Initial Study/Mitigated Negative Declaration

Smith Reservoir Replacement Project

March 2024

Serrano Water District

Figure 2-6. Phase 1 Site Plan

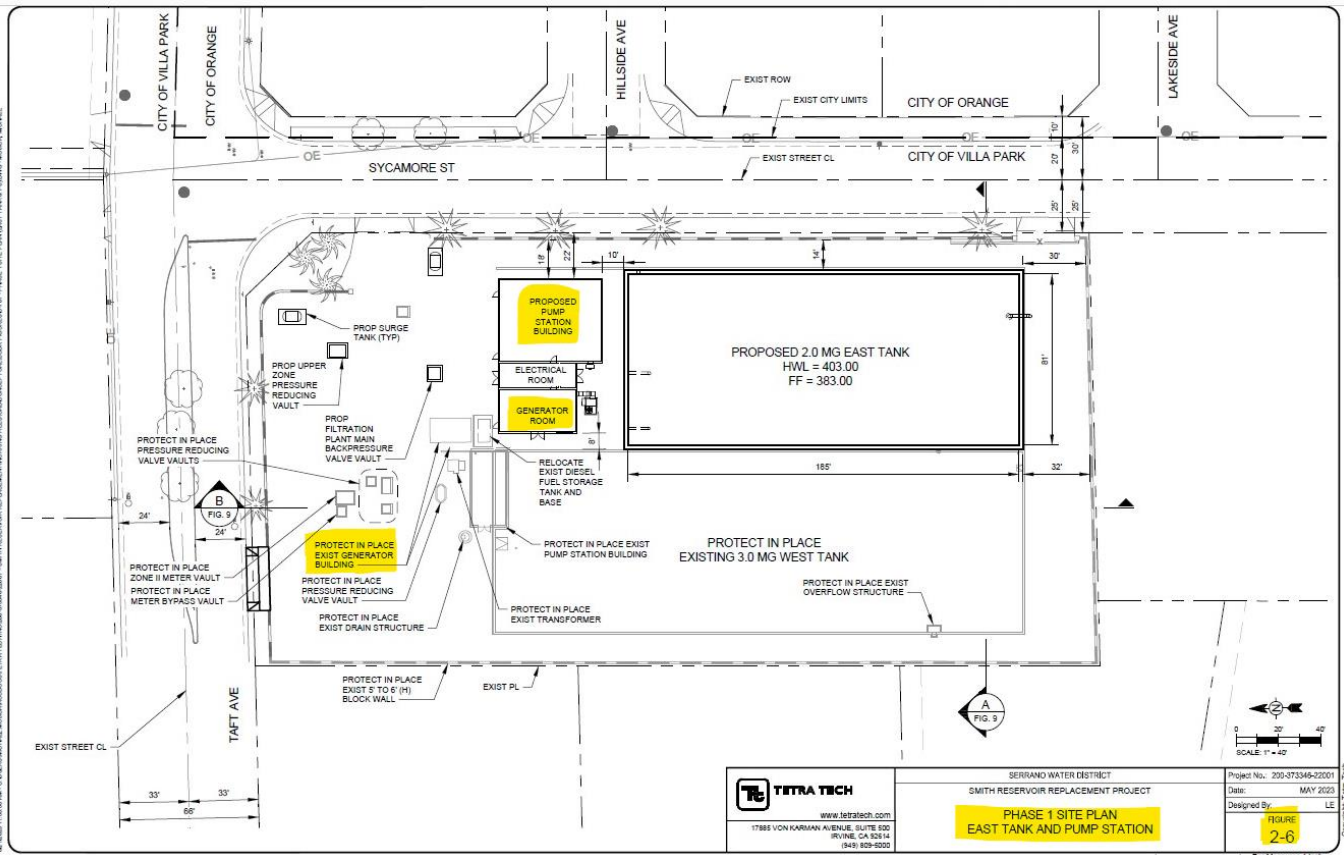
- installation of a new emergency standby generator (diesel fueled) and^{11,12}
- construction of a generator room that is in a different location than the existing generator building (see Figure 2-6 below from MND).^{13,14}

Staff also notes that construction Phase 2 includes:

- removal and disposal of the existing emergency standby generator (diesel fueled) and^{15,16}
- removal and disposal of the existing generator building.^{17,18}

For the Proposed Project location, South Coast AQMD records show a facility ID # of 107461. Under this ID # is an active South Coast AQMD air permit (permit #F79108) for one internal combustion engine of 764 brake horsepower (BHP), diesel fueled, and driving an emergency generator. The Lead Agency states in the MND that a South Coast AQMD construction permit will be required.¹⁹ From information provided in the MND, however, Staff is unable to determine what type of South Coast AQMD air permit application will be required for the new emergency standby generator proposed to be installed during

If implementation of the Proposed Project would require the use of new stationary sources, including but not limited to emergency generators, fire water pumps, boilers, etc., air permits from South Coast AQMD will be required and the role of South Coast AQMD would change from a Commenting Agency to a Responsible Agency under CEQA. In addition, if South Coast AQMD is identified as a Responsible Agency, per CEQA Guidelines Section 15086, the Lead Agency is required to consult with South Coast AQMD. Furthermore, CEQA Guidelines Section 15096 sets forth specific procedures for a Responsible Agency, including making a decision on the adequacy of the CEQA document for use as part of evaluating the applications for air permits. For these reasons, the Final MND should include a discussion about any new stationary equipment requiring South Coast AQMD air permits and identify South Coast AQMD as a Responsible Agency for the Proposed Project.

The Project involves the replacement of the existing 500 kilowatt (kW) generator with a proposed 800 kW emergency generator for operations. The new generator will be subject to SCAQMD Rule 118.1 (Public Safety Provisions for Stationary Emergency Standby Engines), Regulation II (Permits), and Regulation 13 (New Source Review). The emergency generator will limit the size and operating hours to remain below the Rule 3001 Title V applicability threshold of 100,000 tons per year CO₂e and 100 tons per year of greenhouse gasses on a mass basis. The project will require air permits for construction and for operation of the replacement emergency generator. Edits will be made as indicated in **Section 3**.

The Project is a replacement project and operational emissions from the proposed project would largely remain the same as existing operations. Analysis will be added to the Final IS/MND for clarification purposes as to the operational emissions associated with the replacement emergency generator, see **Section 3**.
